CONTRACT NO: 009015 FEDERAL AID NO:
CONTRACT TITLE: SR 520, MONTLAKE TO LAKE WASHINGTON I/C AND BRIDGE
CHANGE ORDER NO: 144 MULTI ISSUE RES NO.4-CITY-2022

WASHINGTON STATE
DEPARTMENT OF TRANSPORTATION
CHANGE ORDER

E MONTLAKE PL & E ROANOKE ST
BUS STOP IMPROVEMENTS

PC	TRC0004
CD	
VPI #	790-948
	BS1
SHEET	20 OF 49

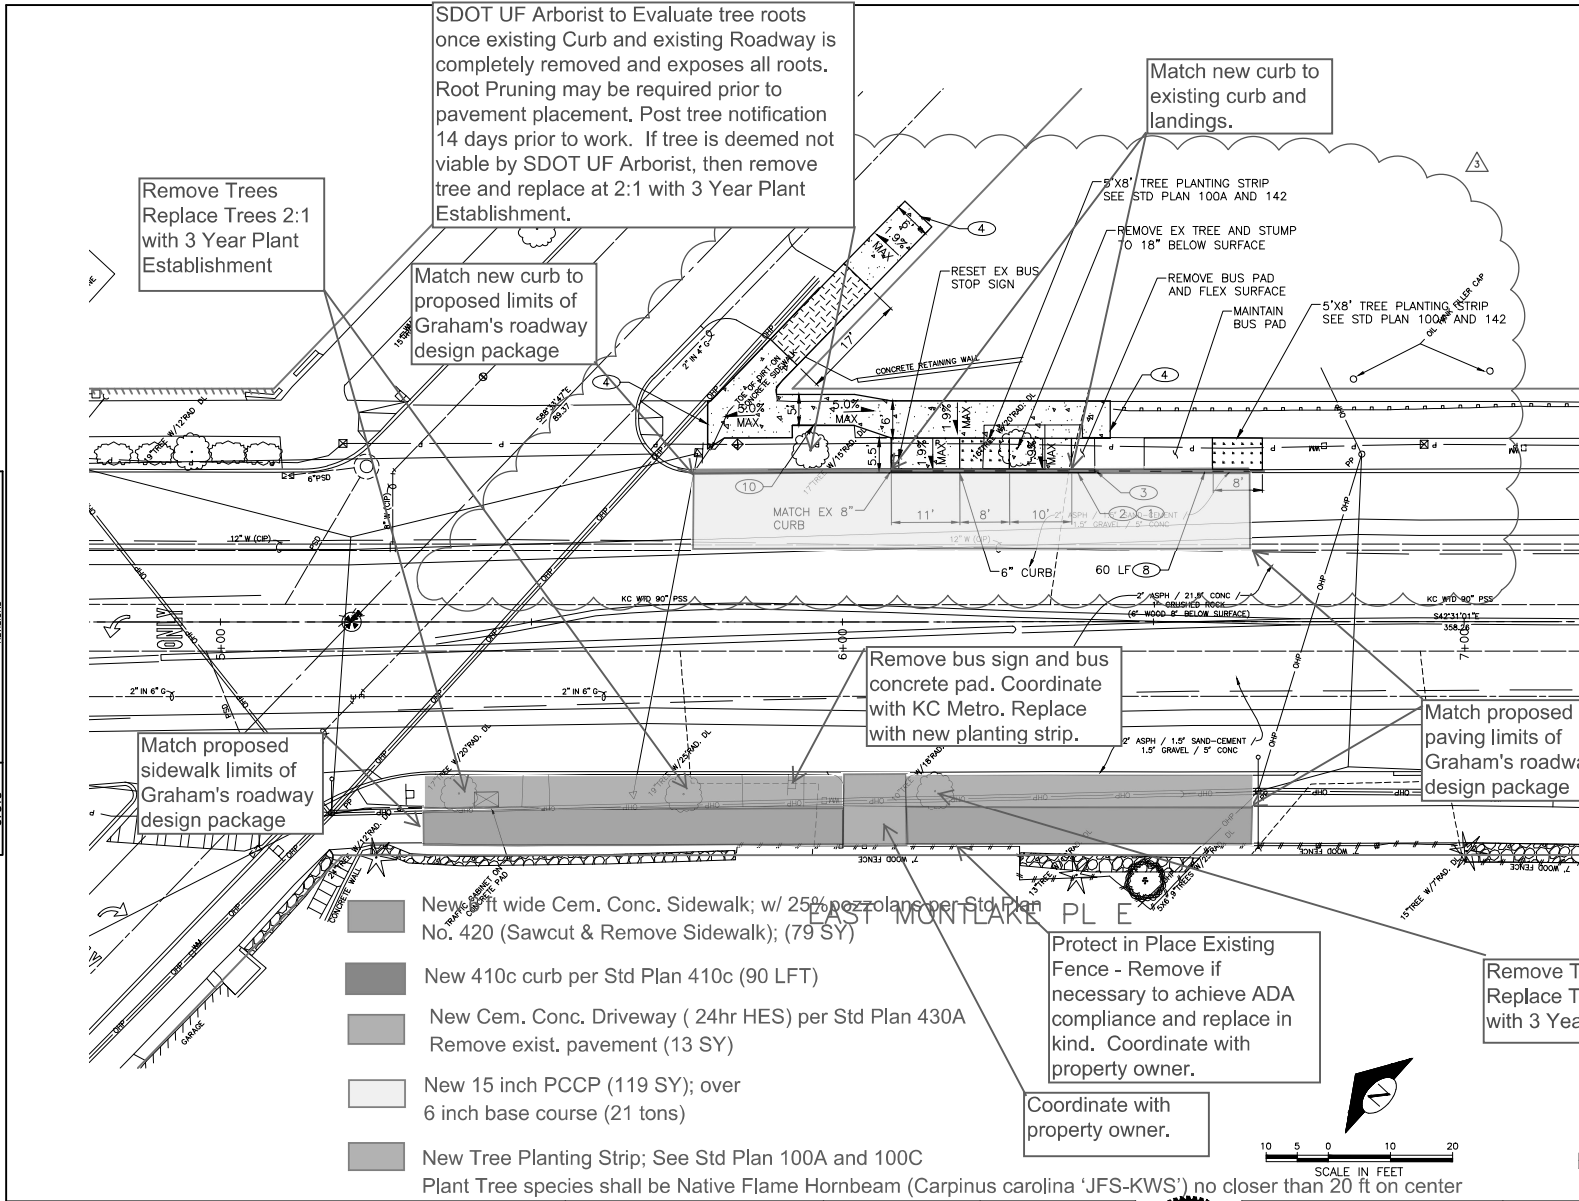
This change order compensates the Design-Builder for the additional Work along Montlake Blvd, south of E Roanoke Street. The scope of Work is shown on page 5 of this change order. Work also includes design and preparation of working drawings, to ensure consistency between the City's concept plan and the Design-Builder's design. The final design for the added Work shall be incorporated into the as-built drawings in lieu of a formal design plan update.

SDOT UF Arborist to Evaluate tree roots
once existing Curb and existing Roadway is
completely removed and exposes all roots.
Root Pruning may be required prior to
pavement placement. Post tree notification
14 days prior to work. If tree is deemed not
viable by SDOT UF Arborist, then remove
tree and replace at 2:1 with 3 Year Plant
Establishment.

Match new curb to
proposed limits of
Graham's roadway
design package

Match new curb to
existing curb and
landings.

Remove bus sign and bus
concrete pad. Coordinate
with KC Metro. Replace
with new planting strip.

Match proposed
paving limits of
Graham's roadway
design package

Match proposed
sidewalk limits of
Graham's roadway
design package

Protect in Place Existing
Fence - Remove if
necessary to achieve ADA
compliance and replace in
kind. Coordinate with
property owner.

- New 8 ft wide Cem. Conc. Sidewalk; w/ 25% pozzolans per Std Plan No. 420 (Sawcut & Remove Sidewalk); (79 SY)
- New 410c curb per Std Plan 410c (90 LFT)
- New Cem. Conc. Driveway (24hr HES) per Std Plan 430A
Remove exist. pavement (13 SY)
- New 15 inch PCCP (119 SY); over
6 inch base course (21 tons)
- New Tree Planting Strip; See Std Plan 100A and 100C
Plant Tree species shall be Native Flame Hornbeam (Carpinus carolina 'JFS-KWS') no closer than 20 ft on center

FILE NAME: WTYLIPW01ICS01VCS_pdf_work_dh5831952421_613512_C9015_PS_PV_012.dgn	REGION NO: 10	STATE: WASH	FED. AID PROJ. NO.				SR 520 MONTLAKE TO LAKE WASHINGTON IC AND BRIDGE REPLACEMENT	PLAN REF. NO. PV012
TIME: 4:18:29 AM	DATE: 8/27/2020	DESIGNED BY: K. KOZAI	ENTERED BY: K. KOZAI

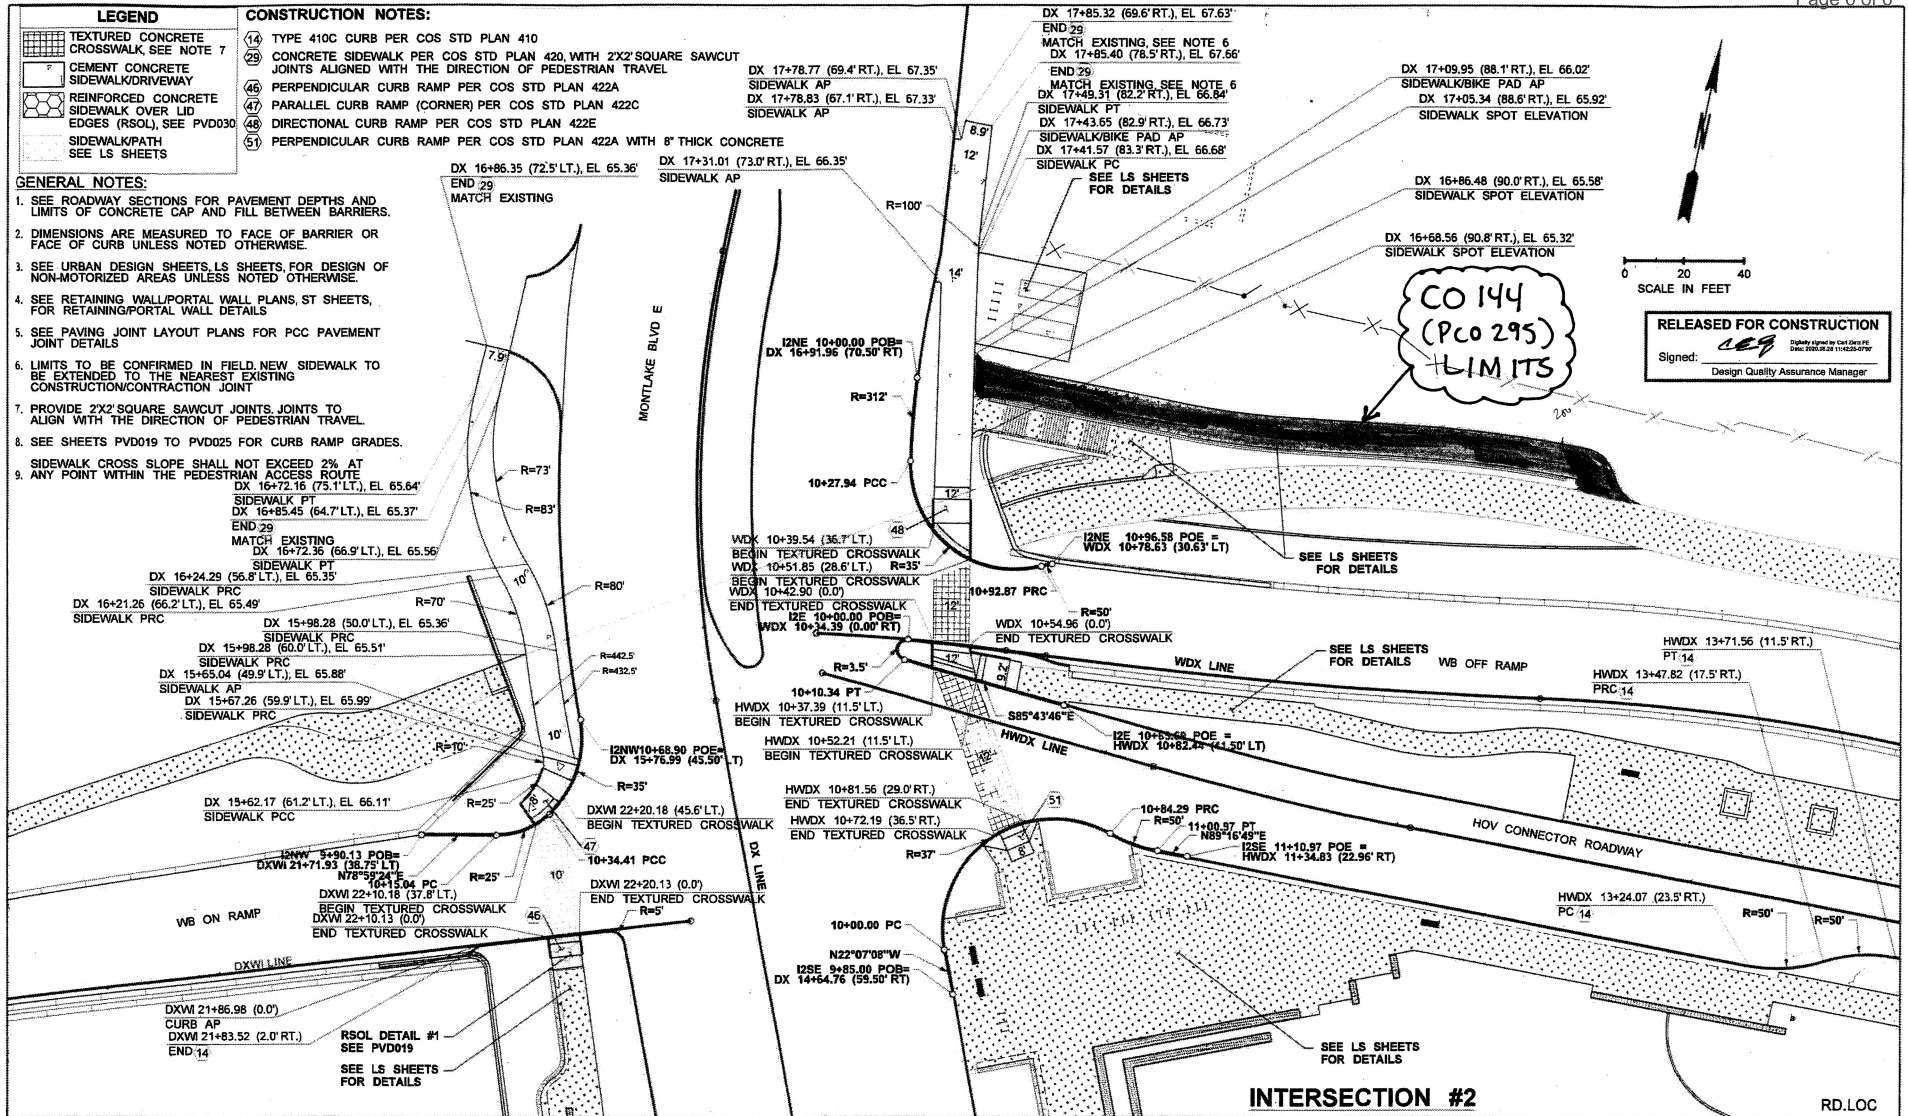
This change order compensates the Design-Builder for increasing the thickness of the portland cement concrete pavement (PCCP) to 6 inches along a section of concrete path in the Old Canal Reserve (OCR) area. With this change, the total pavement depth along this trail section will be 6 inches PCCP over 6 inches Mineral Aggregate Type 2. Refer to page 6 of this change order for limits. This change shall be incorporated into the as-built drawings in lieu of a formal design plan update.
